GARAGE ADDITION
ELEVATIONS
1065 ROCK CREEK CANYON RD
COLORADO SPRINGS, CO 80926

DISAPPROVED
06/07/2021 9:17:39 AM
shelley
CONSTRUCTION

**GARAGE ADDITION
FLOOR PLANS**
1065 ROCK CREEK CANYON RD
COLORADO SPRINGS, CO 80926

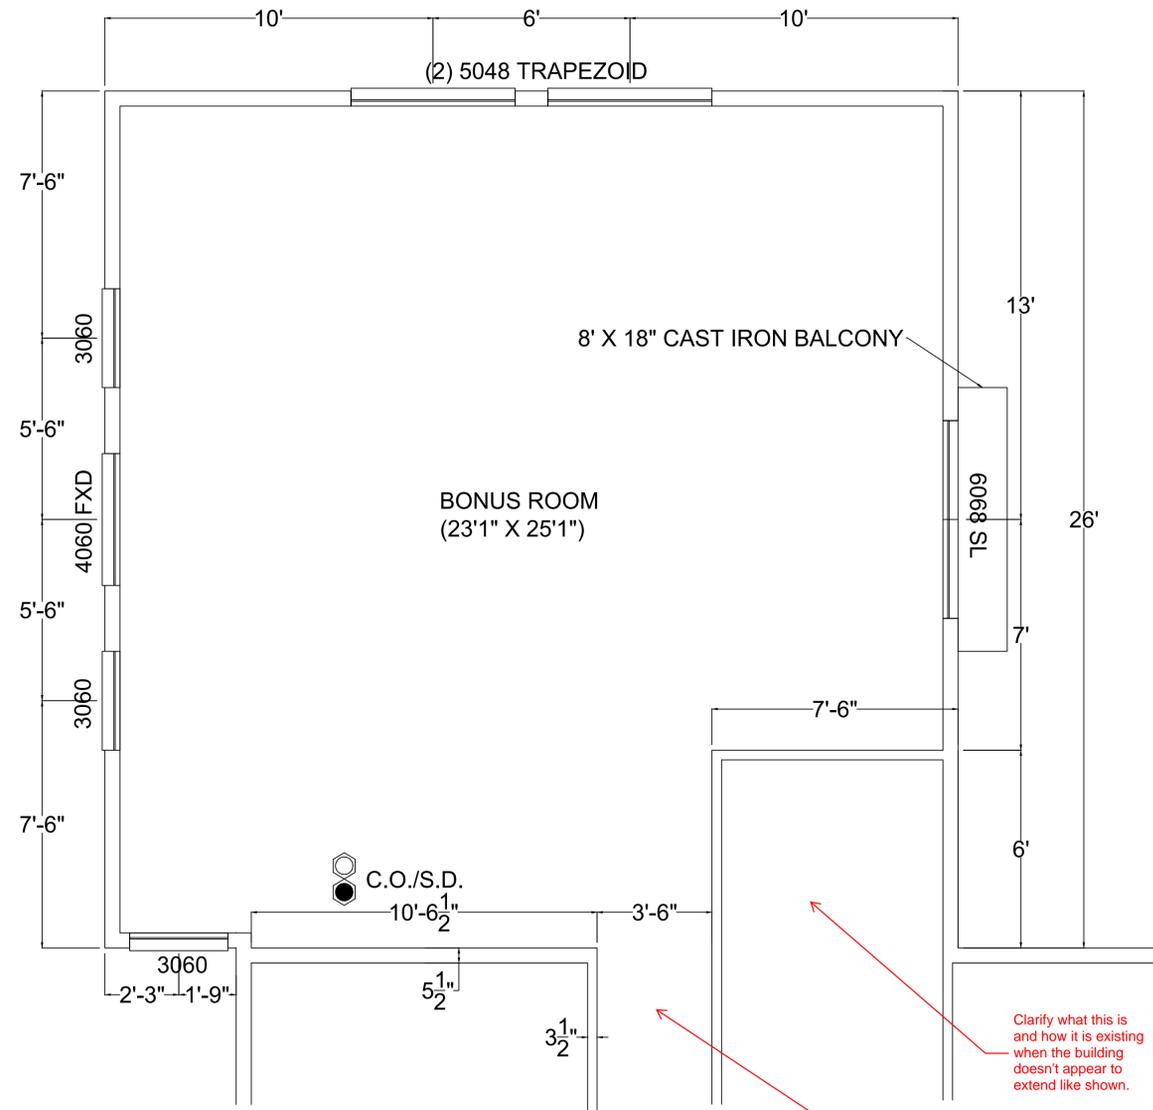
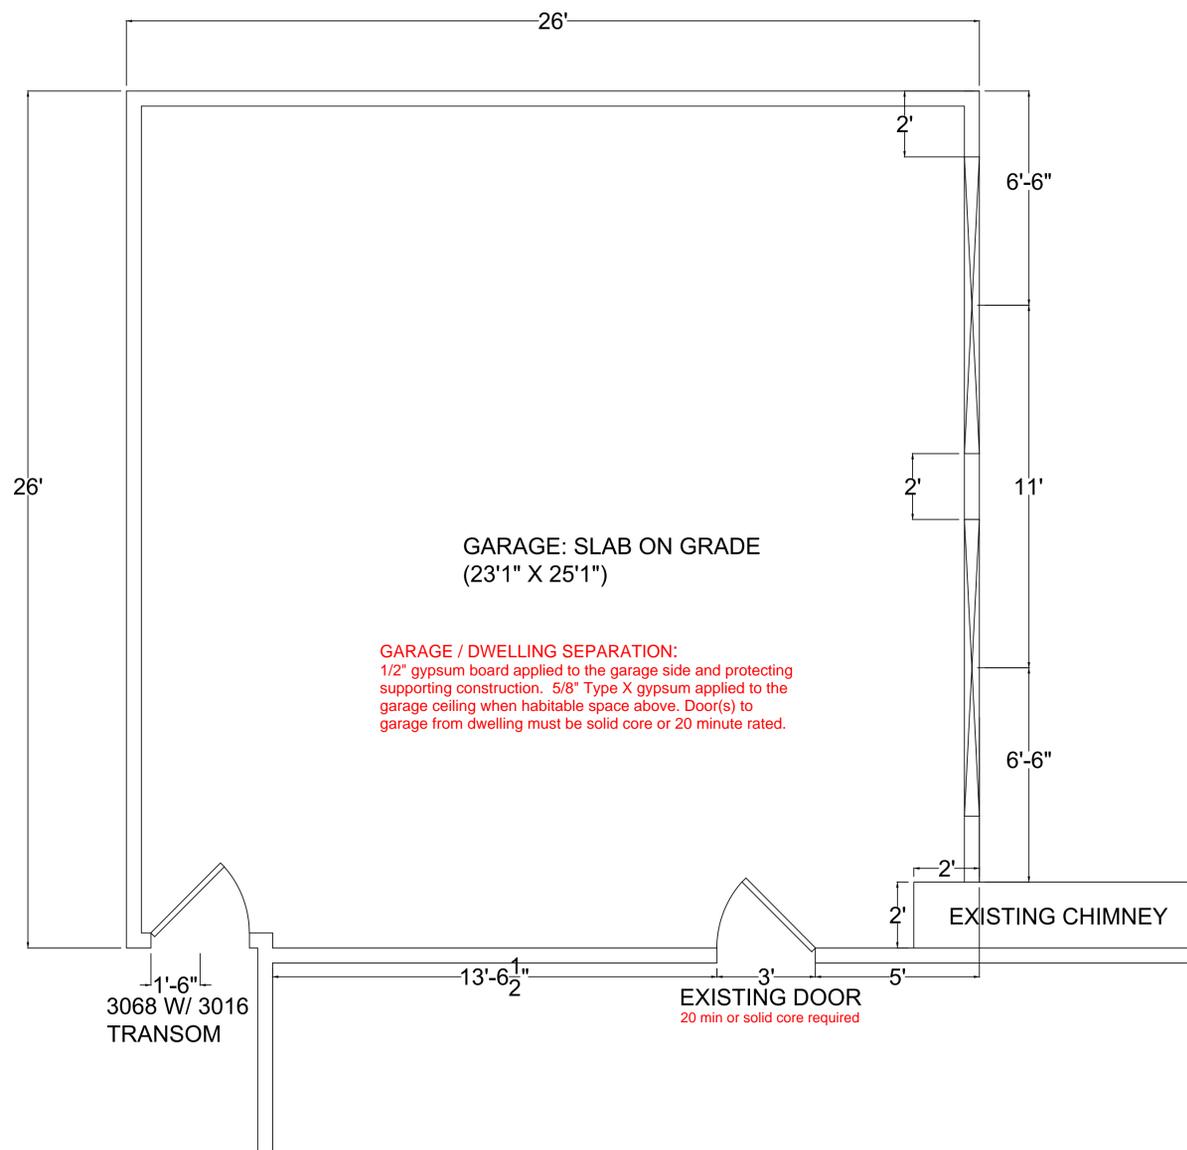
[EB] R313.1.1 Alterations, repairs and additions. When interior alterations, repairs or additions requiring a permit occur, or when one or more sleeping rooms are added or created in existing dwellings, the individual dwelling unit shall be provided with smoke AND carbon monoxide alarms located as required for new dwellings; the smoke alarms shall be interconnected and hard wired.

Specify how all window operate

GARAGE ADDITION
FRAMING PLANS
1065 ROCK CREEK CANYON RD
COLORADO SPRINGS, CO 80926

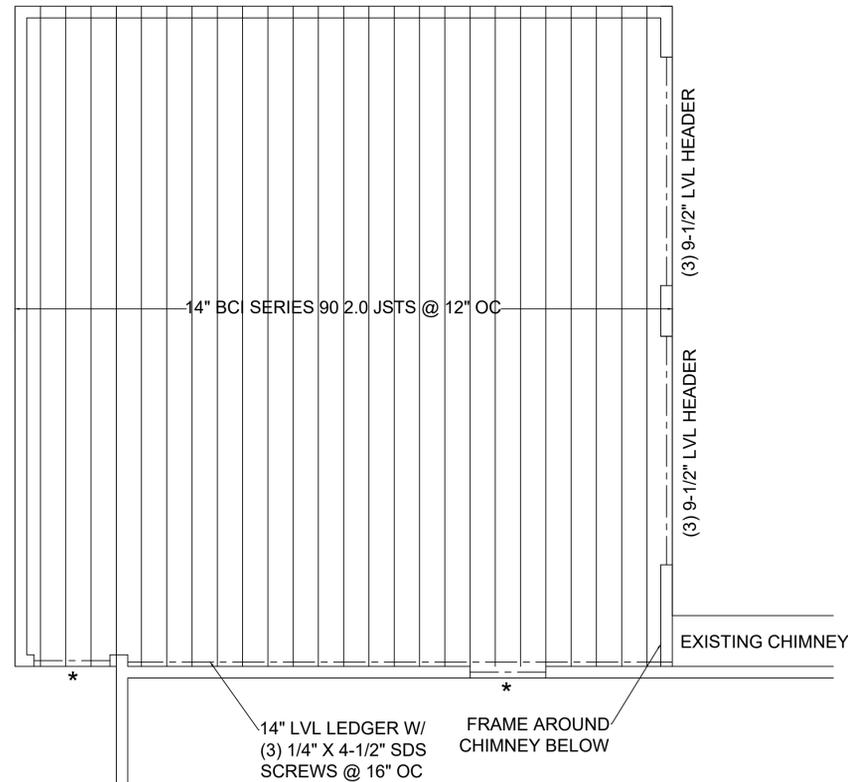
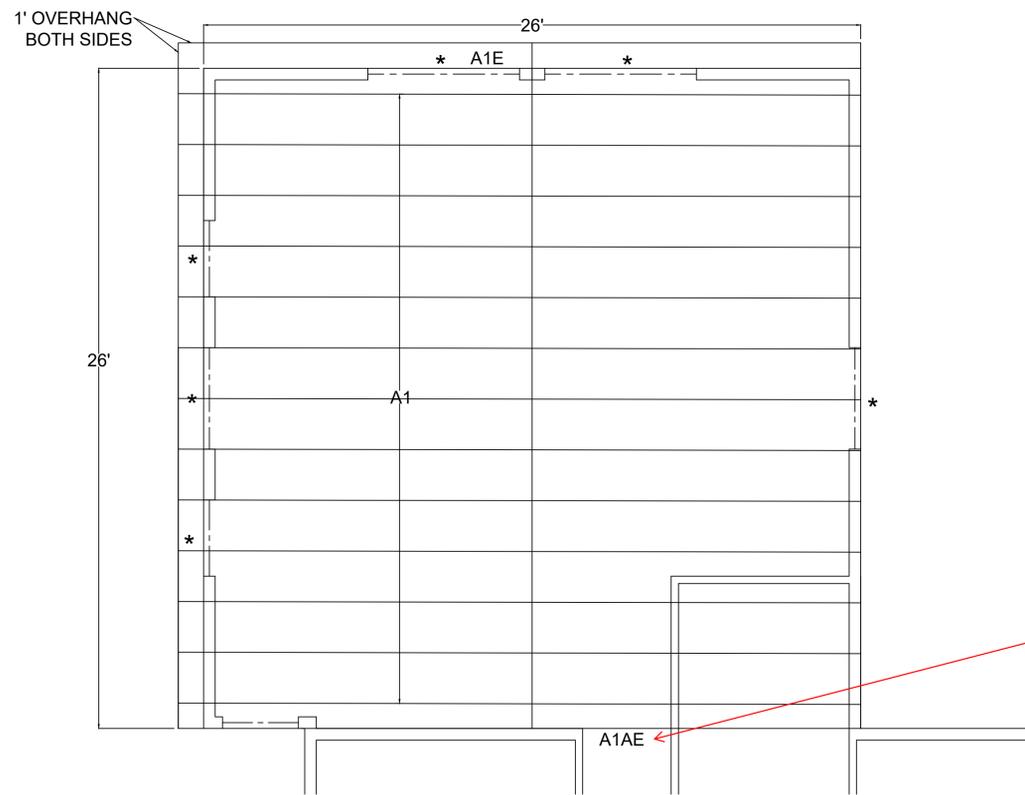
Is this an existing opening that requires no new or change in header? Appears to be a bearing wall for existing dwelling based on elevations.
